McCaffrey Interchange

Ref: Newcastle Inner City Bypass – Rankin Park to Jesmond
McCaffrey Drive Interchange – Submission for Review

Jesmond Interchange

Ref: Newcastle Inner City Bypass – Jesmond to Rankin Park
Jesmond Interchange – Submission for Review.

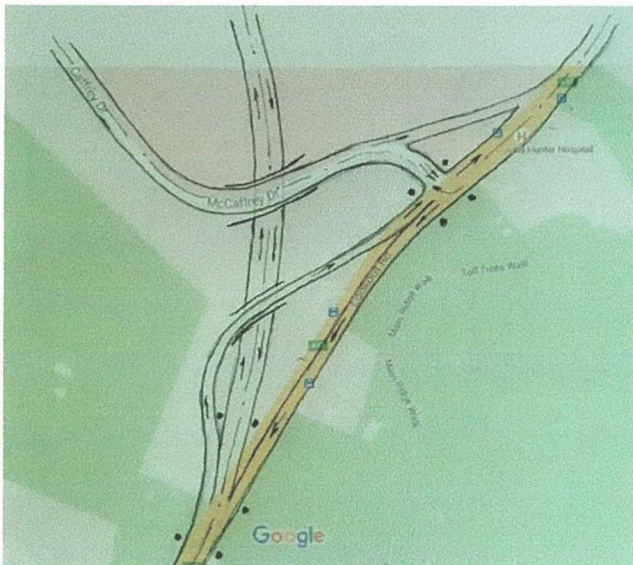
No northbound access to the Bypass from McCaffrey except via Grandview Rd or via Grandview Rd>Marshall St/Cardiff Rd.

No southbound access to the Bypass from McCaffrey except via Grandview Rd or via Grandview Rd>Marshall St>Cardiff Rd.

Nil consideration for "peak-flow" entering Bypass northbound or southbound from McCaffrey to enter the Bypass

No northbound or southbound access from the Bypass to the John Hunter Hospital entry on Lookout Rd.

No northbound access to the Bypass, nor to the Lookout Rd entry to the hospital for those residents on Lookout Rd south of the McCaffrey Interchange.

McCaffrey Bridge over the Bypass is contrary to landform.

2016 RMS Revised Design

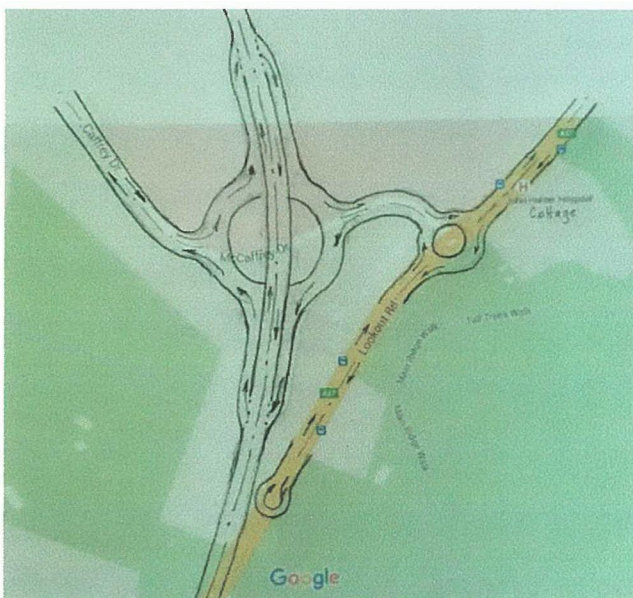
Still no northbound access to the Bypass from McCaffrey except via Grandview Rd or via Grandview Rd>Marshall St>Cardiff Rd.

Added, is a southbound access from McCaffrey Drive via a one-way residential road on Lookout Rd plus two traffic light systems.

Still no consideration given for "peak traffic flows" northbound or southbound to/from the Bypass and McCaffrey Drive.

Still no southbound access to John Hunter Hospital from the bypass, nor to the Hospital and Lambton or New Lambton for those residents on Lookout Rd south of McCaffrey Drive.

Still no northbound entry to the Bypass, or northbound entry to their property for those residents on Lookout Rd south of McCaffrey Drive.

Two bridges and the undercut Bypass are contrary to landform

2016 RMS Proposed Jesmond Interchange with highly Complex Traffic Light Control on Newcastle Rd

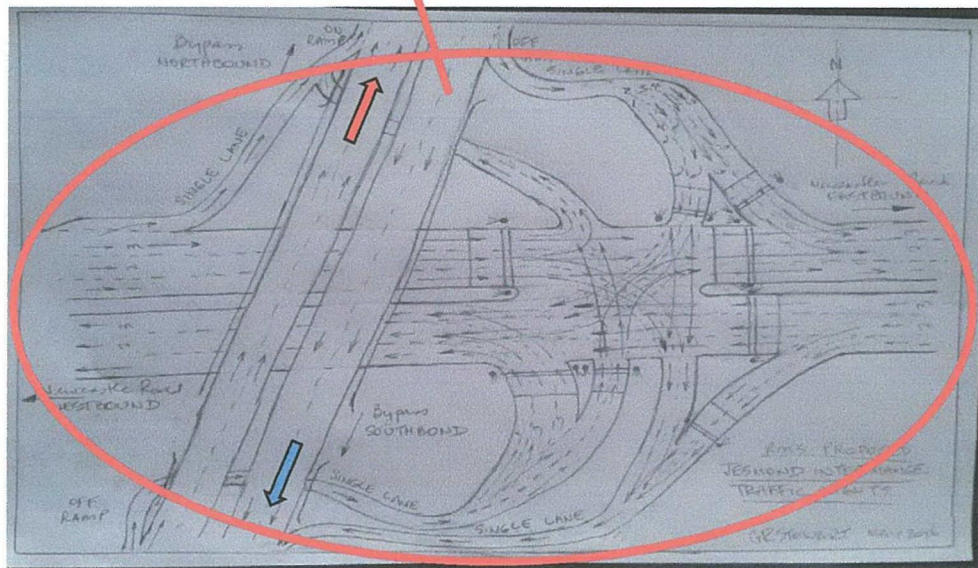
The use of traffic lights in highway or bypass applications can be a serious safety hazard usually indicating a lack of road planning, and the installation of such a complicated series of traffic lights at the Jesmond Park Interchange would be a serious disruption to traffic Flow with an added risk for local and visiting drivers entering and leaving the bypass suddenly being confronted by traffic signals and having to make a highly complex decision on the correct pathway through this incredibly complex set of traffic lights when it is totally unnecessary.

The complexity of the traffic light control system being recommended by the RMS for this Jesmond Park Interchange is so disturbing that the above suggestion for a simpler and more cost-effective option might prove worthy of consideration.
